**PLANNING COMMISSION RECOMMENDATIONS  
TO THE BOARD OF COUNTY COMMISSIONERS  
December 5, 2013**

TO: Michael Mabrey  
FROM: Ejaz Khan, P.E.; Traffic Engineer   
DATE: October 1, 2013  
SUBJECT: Livingston Mountain Quarry Overlay District.

SUBJECT: Livingston Mountain Quarry Overlay District.

TO: Michael Mabrey  
FROM: Ejaz Khan, P.E.; Traffic Engineer EK  
DATE: December 27, 2013  
SUBJECT: Berry Road Quarry Overlay District.

VICINITY MAP

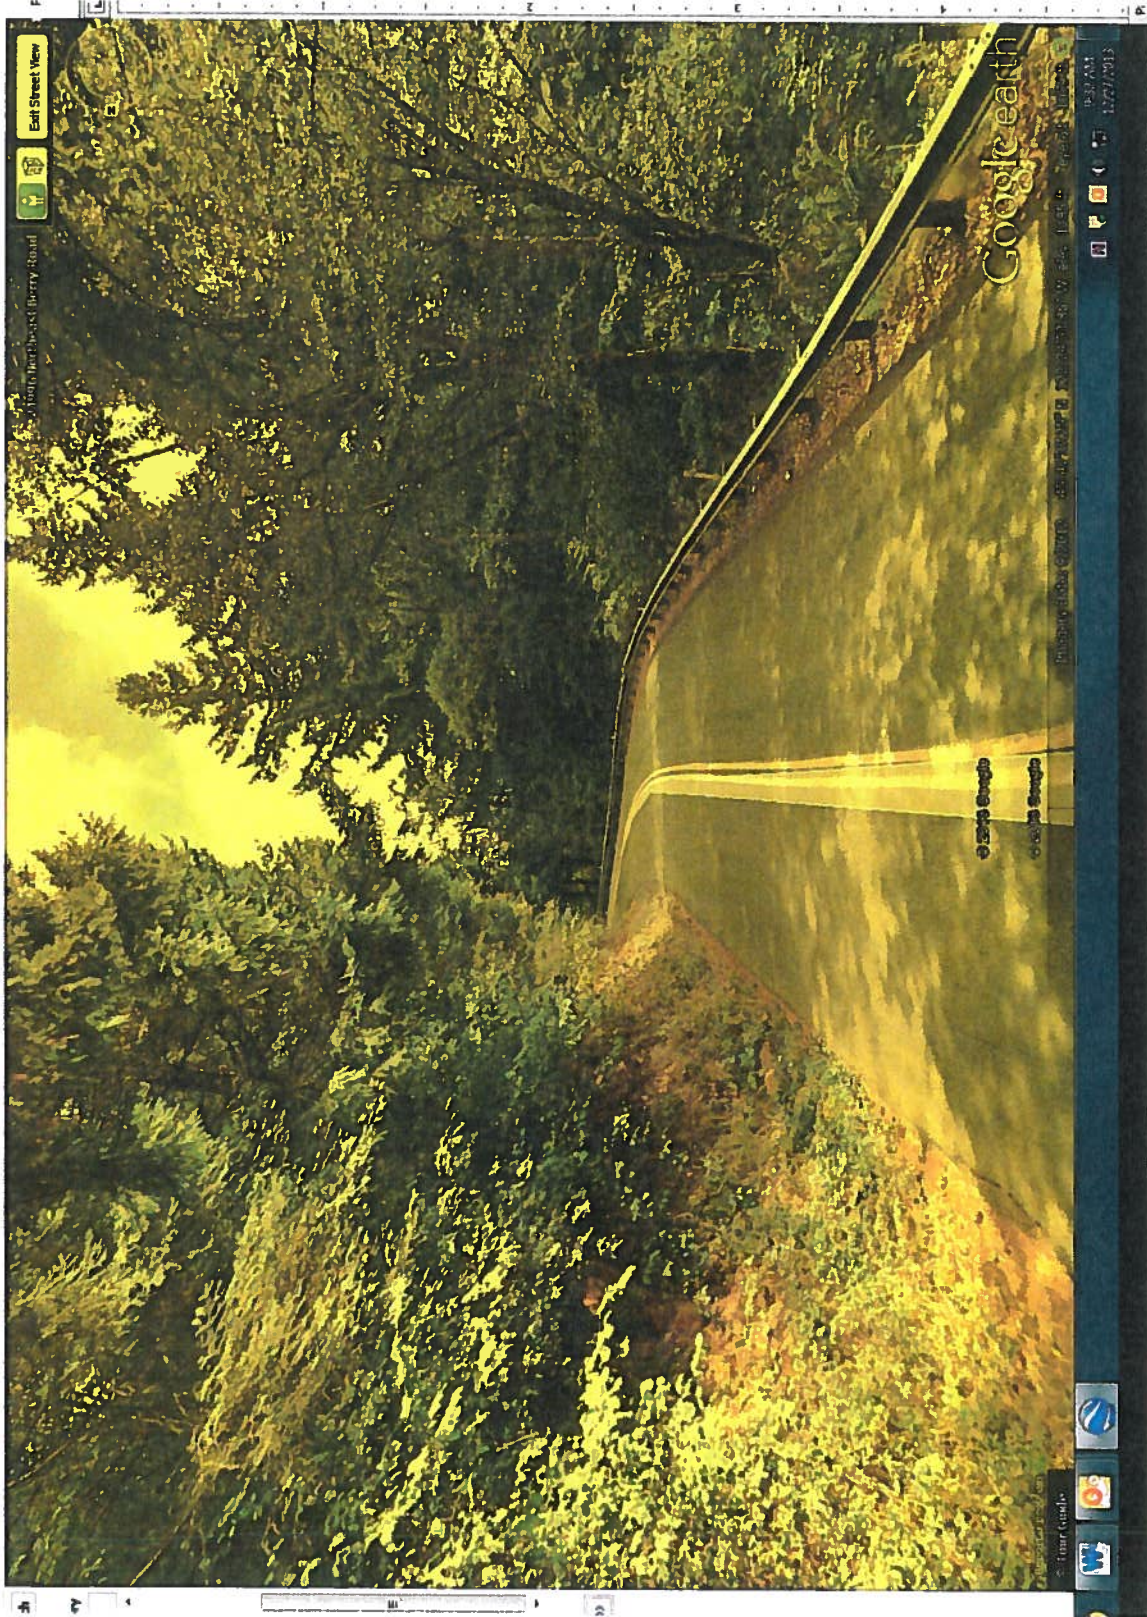
I have evaluated the Berry Road corridor east of NE 240<sup>th</sup> Avenue for gravel truck traffic safety and operations. Berry Road is a two lane paved roadway with total pavement width ranging between 23 feet and 26 feet. The entire corridor has significant horizontal and vertical curves, steep grades and combination horizontal and vertical curves. The corridor is centerline stripped up to Kaskilla, a distance of approximately 1.5 miles. East of Kaskillah the road width narrows down to approximately 18 feet and is not stripped. Berry Road is a low volume road and carries an estimated traffic volume of 125 vehicles per day. Crash data indicate two crashes over the length of the corridor over a period of five years. The sample size is too small to make a conclusive determination over regarding the safety record of the corridor.

Berry Road at 239<sup>th</sup> Circle- Looking East- Another example of tight horizontal curve combined with roadway grade and sight distance deficiency.

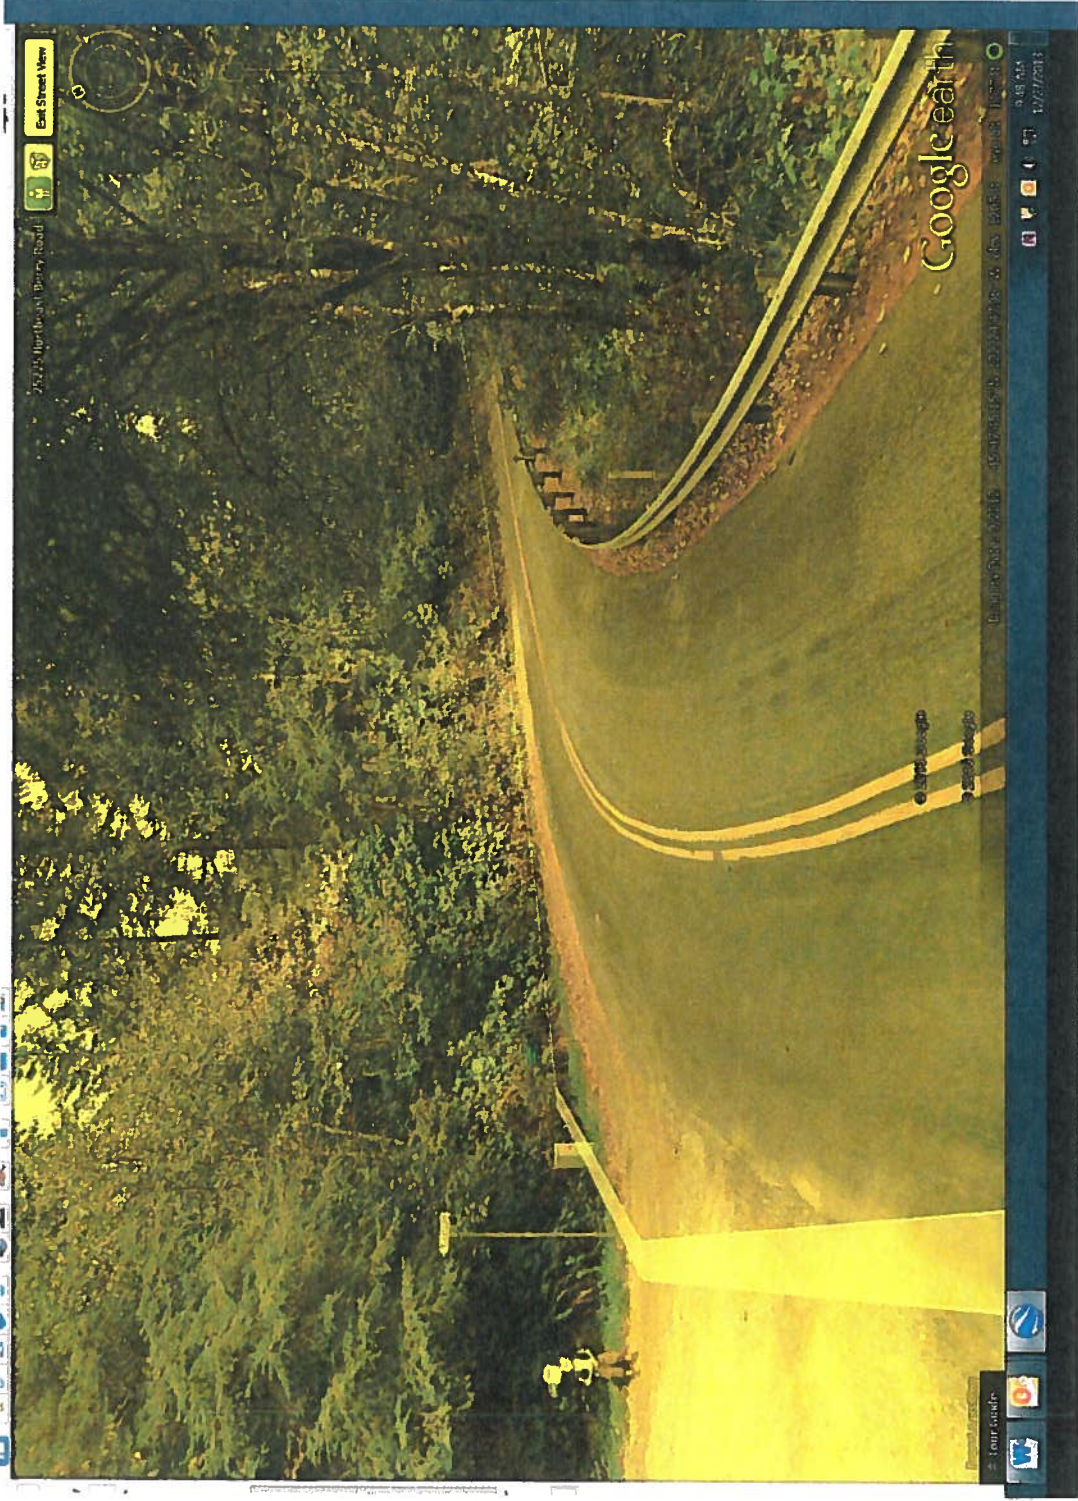
Visual assessment of the pavement condition indicates the pavement to be in poor condition. Guardrails along the corridor are installed against the edge of the travelled way with no shy distance. Vehicles appeared to have sideswiped against the guardrail. The entire corridor is windy with sharp curves. The terrain severely limits the sight distance of oncoming vehicles at various locations throughout the corridor.

1. Given that there would need to be certain shy distance or clearance between the guardrail and the vehicle and clearance between opposing vehicles the lane available width is inadequate and the corridor would be unsuitable for gravel truck traffic.

2. The lack of available line of sight, especially at sharp curves, between approaching vehicle further adds to the corridor's unsuitability for heavy truck traffic from traffic safety and operations point of view.

3. The corridor is on continuous downhill grade from the DNR land until it reaches 240<sup>th</sup> Avenue. This would require continuous braking action on part of the loaded gravel trucks which in turn would destroy the pavement. Because of the length of the corridor that the loaded trucks will have to trek downhill, it is very likely that drivers will try to conserve on the mechanical braking system and use engine compression to control speed. This will generate loud noise and complaints from the area residents.
